**Record of Decision
Hexagon Laboratories Site
Operable Unit No. 2
Bronx County
Site Number 203003**

July 2002

Hexagon Laboratories Inactive Hazardous Waste Disposal Site Bronx County, New York Site No. 203003 Operable Unit No. 2

Hexagon Laboratories Operable Unit No. 2 Proposed Remedial Action Plan Bronx County Site No. 203003

HEXAGON LABORATORIES
REMEDIAL INVESTIGATION
SAMPLING LOCATIONS
FIGURE 2

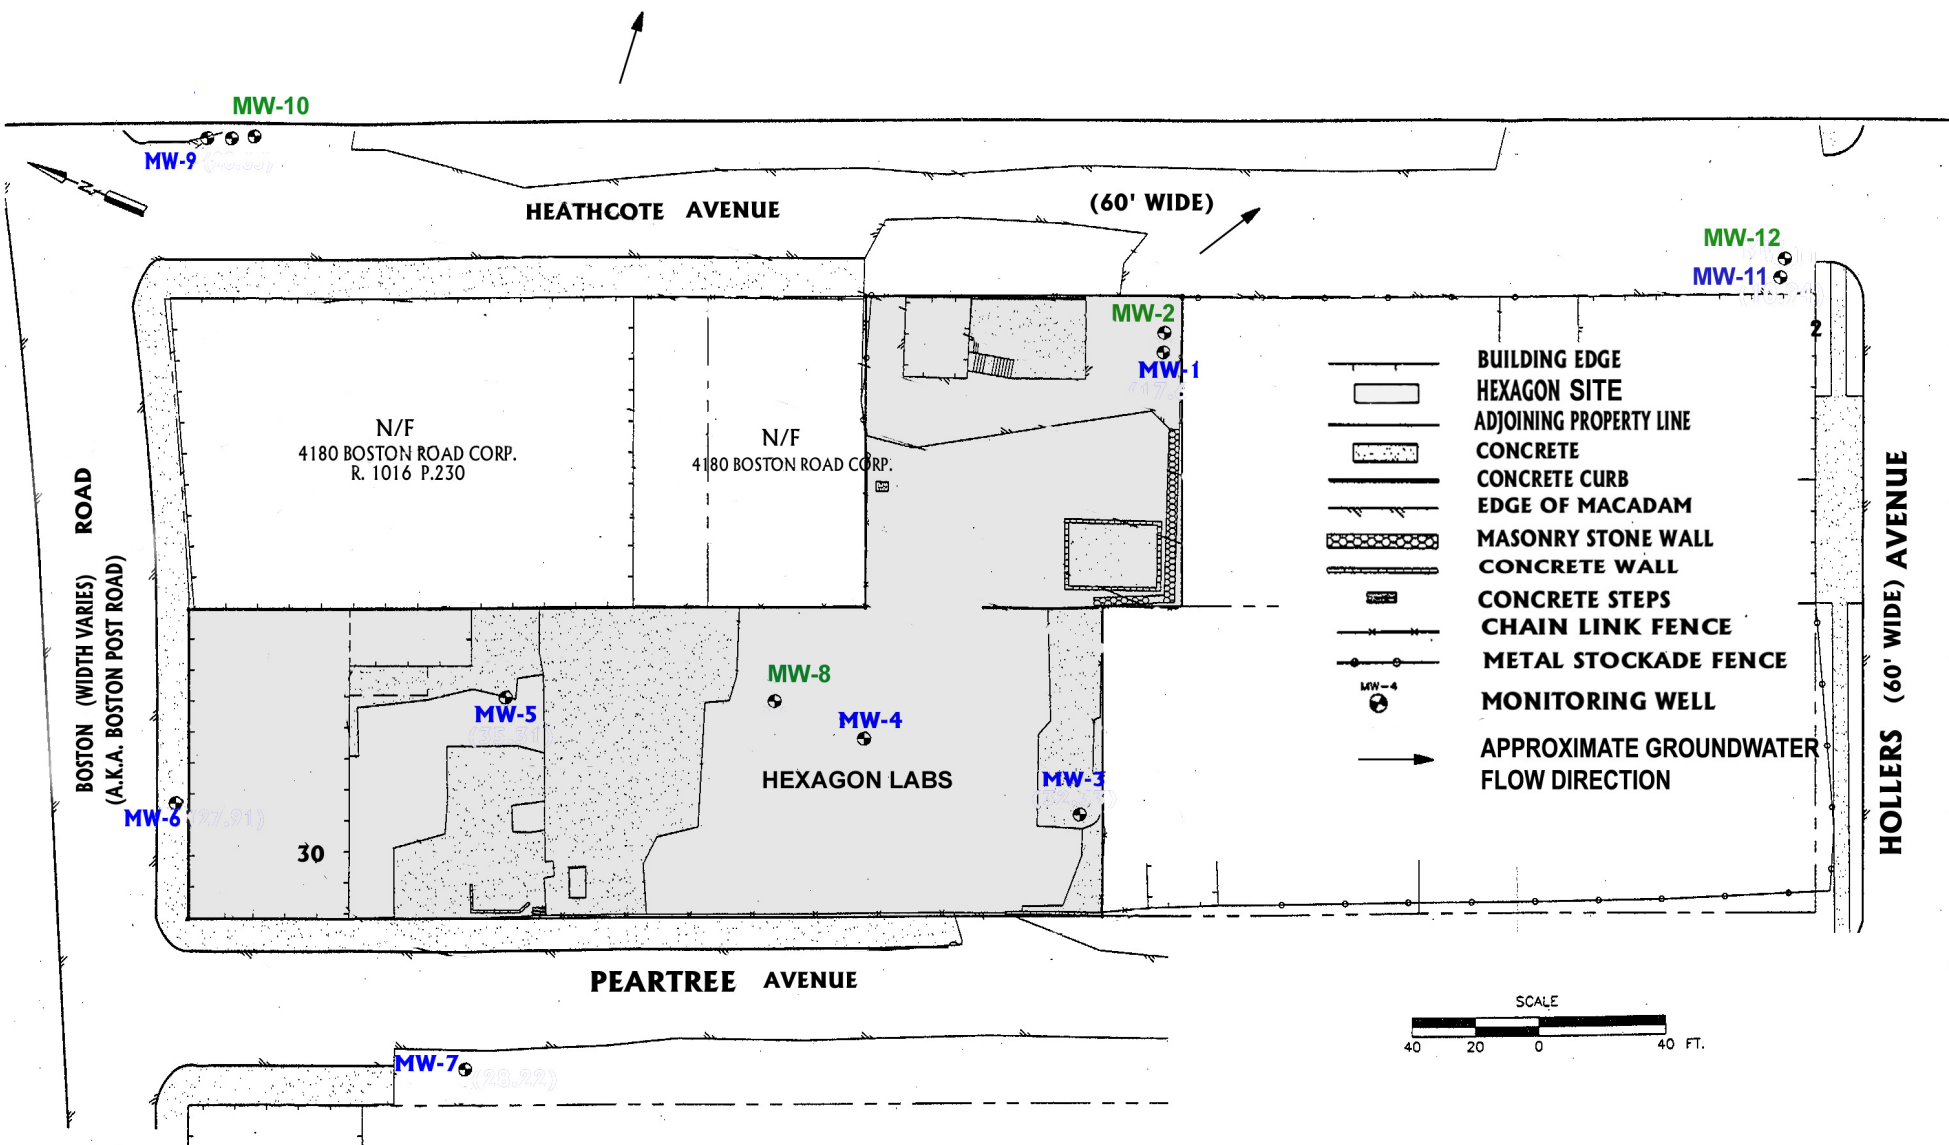
VOCs were detected at concentrations greater than the NYSDEC Class GA groundwater standards in all six of the on-site monitoring wells, MW-1, MW-2, MW-3, MW-4, MW-5, and MW-8 (see Figure 2). The shallow wells (MW-1, MW-3, MW-4, MW-5, MW-6, MW-7, MW-9, and MW-11) are all screened between 2 and 6 feet to 12 to 16 feet deep. The deeper wells vary from MW-2 (screened from 40 to 50 feet below ground surface (bgs)) to MW-8 (75 to 85 feet bgs). Highest concentrations were observed in monitoring well MW-3 (South Yard), monitoring wells MW-4 and MW-8 (New Plant shallow and deep wells, respectively), and monitoring well MW-5 (Old Plant). The maximum concentration of 1,1-dichloroethene was found in MW-3 at 200 ppb [groundwater standard of 5 ppb]. Several chemicals were detected at their maximum on-site concentrations in MW-4: 1,1-dichloroethane at 16,000 ppb [5 ppb]; 1,2-dichloroethene at 30,000 ppb [5 ppb]; chloroform at 22,000 ppb [7 ppb]; 1,2-dichloroethane at 110,000 ppb [0.6 ppb]; 1,1,1-trichloroethane at 270 ppb [5 ppb]; trichloroethene at 10,000 ppb [5 ppb]; tetrachloroethene at 9,200 ppb [5 ppb]; toluene at 270,000 ppb [5 ppb]; ethylbenzene at 4,400 ppb [5 ppb]; and xylene at 19,000 ppb [5 ppb]. Styrene was detected at a maximum concentration of 24 ppb [5 ppb] in MW-5. Several chemicals were detected at their maximum concentrations in MW-8; vinyl chloride at 1,400 ppb [2 ppb]; methylene chloride at 6,400 ppb [5 ppb]; acetone at 590,000 ppb [50 ppb]; and benzene at 45,000 ppb [0.7 ppb].

VOCs were detected at concentrations greater than the NYSDEC Class GA groundwater standards in four of six off-site monitoring wells (MW-6, MW-10, MW-11, MW-12, see Figure 2). In general, VOC concentrations were lower in off-site wells than in on-site wells, except for MW-10 (deep well east of site). VOC concentrations in MW-10 were comparable to on-site monitoring wells MW-1 and MW-2. The maximum off-site concentrations of volatile organic chemicals were found in MW-10: Chloroethane was found at 950 ppb [groundwater standard of 50 ppb]; 1,1-dichloroethane was found at 6 ppb [5 ppb]; 1,2-dichloroethane was found at 14 ppb [5 ppb]; benzene was found at a maximum off-site concentration of 560 ppb [0.7 ppb]; toluene at 65 ppb [5 ppb]; chlorobenzene at 1,600 ppb [50 ppb]; ethylbenzene at 20 ppb [5 ppb]; and xylene at 14 ppb [5 ppb].
